PLANNING REPORT

PLANNING AND ZONING COMMISSION

2. Infiniti of Dublin **3890 Tuller Road**
08-009CDDS **Corridor Development District Sign Review**

Proposal: Modifications to existing signs to reflect a new logo and new colors for a car dealership located within the Corridor Development District located on the north side of Tuller Road, approximately 1,200 feet east of Village Parkway.

PROPOSED SIGN

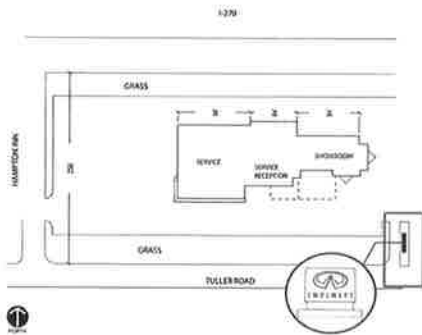
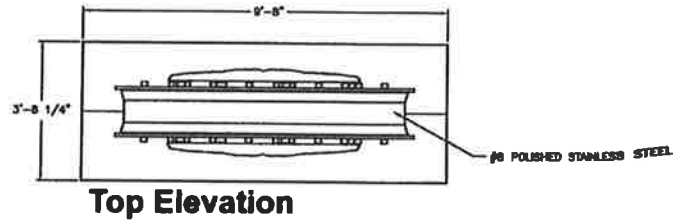
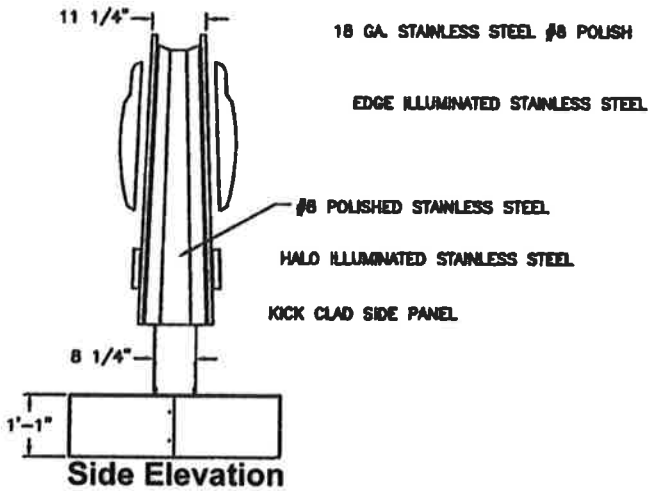
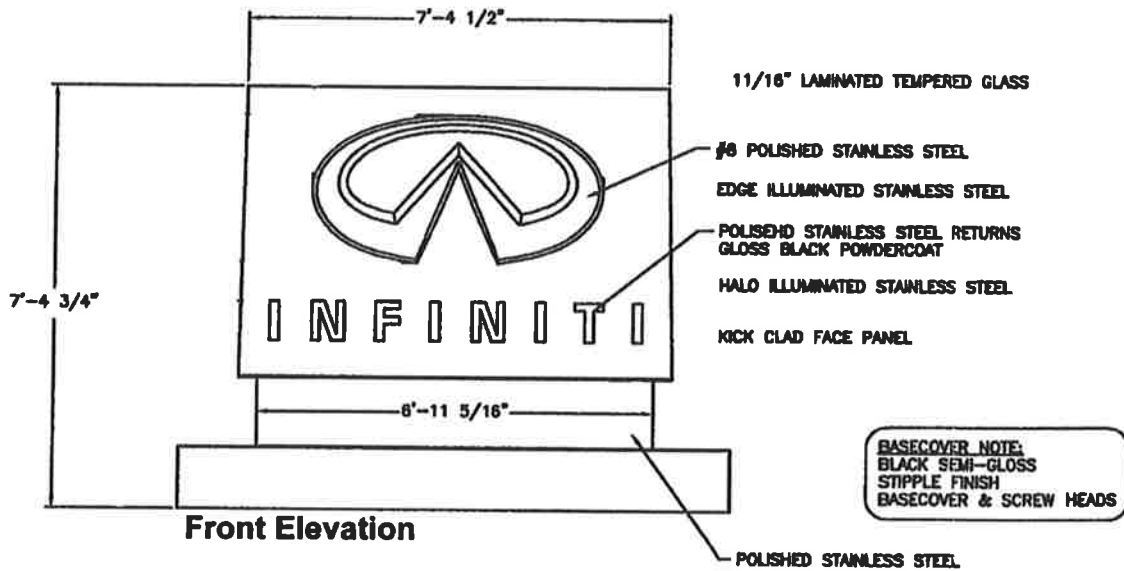
The proposed sign will be in the same location as the existing sign within the island of the Tuller Road entrance drive, 16 feet from the Tuller Road right-of-way. The sign will have a 38-square-foot internally illuminated sign cabinet mounted on top of a 12-inch black base and 15-inch polished stainless steel base. The height of the sign has increased from 4 feet to 7 feet 5 inches, which meets Code.

The proposed design include a white, tempered glass background and polished stainless steel sign cabinet with a stainless steel Infiniti logo and black pin-mounted lettering. The proposed sign continues the Infiniti lettering with the logo relocated above the lettering. The logo meets the maximum permitted size of 20 percent of the permitted sign area for secondary images.

Criteria are met: The proposed sign meets all requirements of the Zoning Code and is compatible with other signs in the area. Removing the I-270 wall sign and the ground sign along Sawmill Road sign contributes to the character of the area by reducing the amount of sign clutter and should be completed within 30 days of the final inspection of the construction of the new Tuller Road sign (Condition 1). Landscaping around the base of the sign shall be required at the time of the sign installation and shown on the sign permit (Condition 2).

- 1) Removal of the I-270 wall sign and the ground sign along Sawmill Road sign shall be completed within 30 days of the final inspection of the construction of the new Tuller Road sign; and
- 2) Landscaping around the base of the sign shall be required at the time of the sign installation and shown on the sign permit.
